SERVICE BULLETIN

Kodak MULTILOADER

SERVICE BULLETIN NO. 277

March 1998

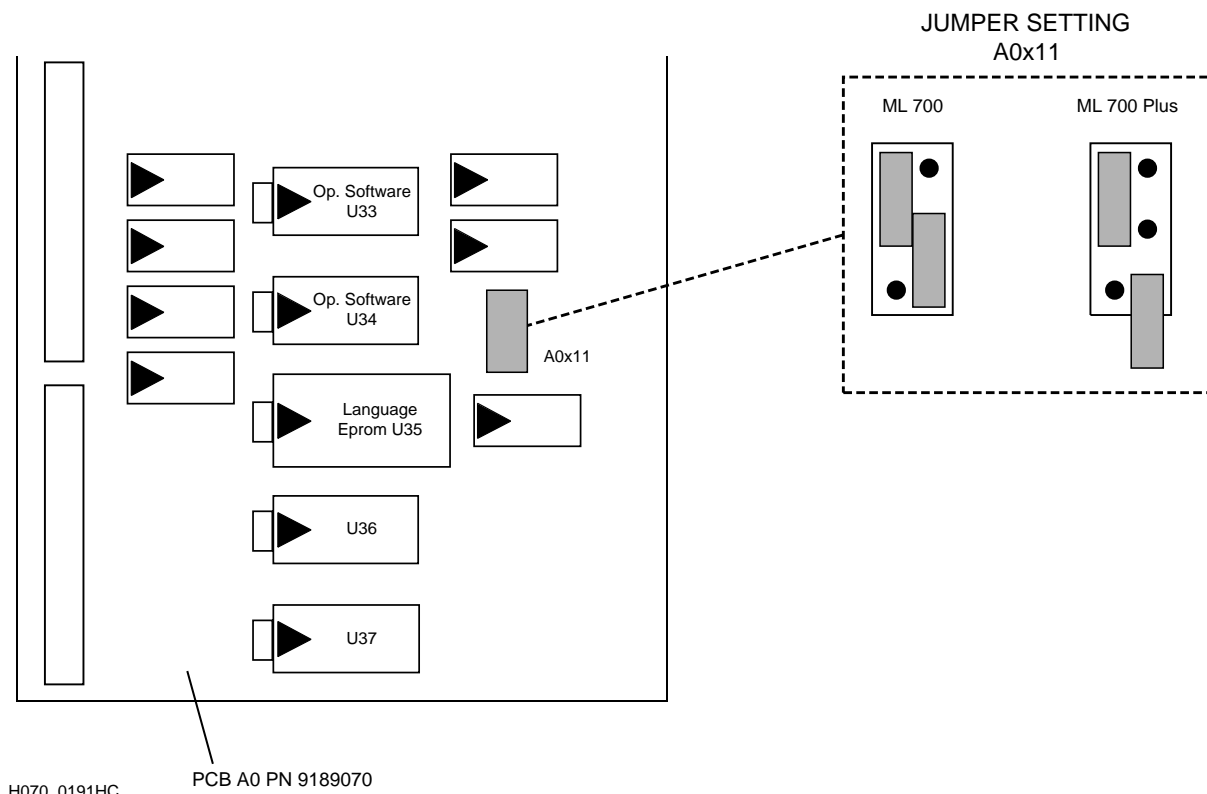
When you install a new PRINTED CIRCUIT BOARD A0, Part No. 9189070, see the figure below to set the JUMPER A0X11.

The MULTILOADER 700, A15 BOARD which was part of Mod 24, Publication No. MA3053-24, 7/96, is no longer necessary. Insert the LANGUAGE EPROM U35 directly into the SOCKET U35.

The MULTILOADER 700 PLUS, A15 BOARD which was used up to serial number 3372, 50 Hz and serial number 7273, 60 Hz is no longer necessary. Insert the LANGUAGE EPROM U35 directly into the SOCKET U35.
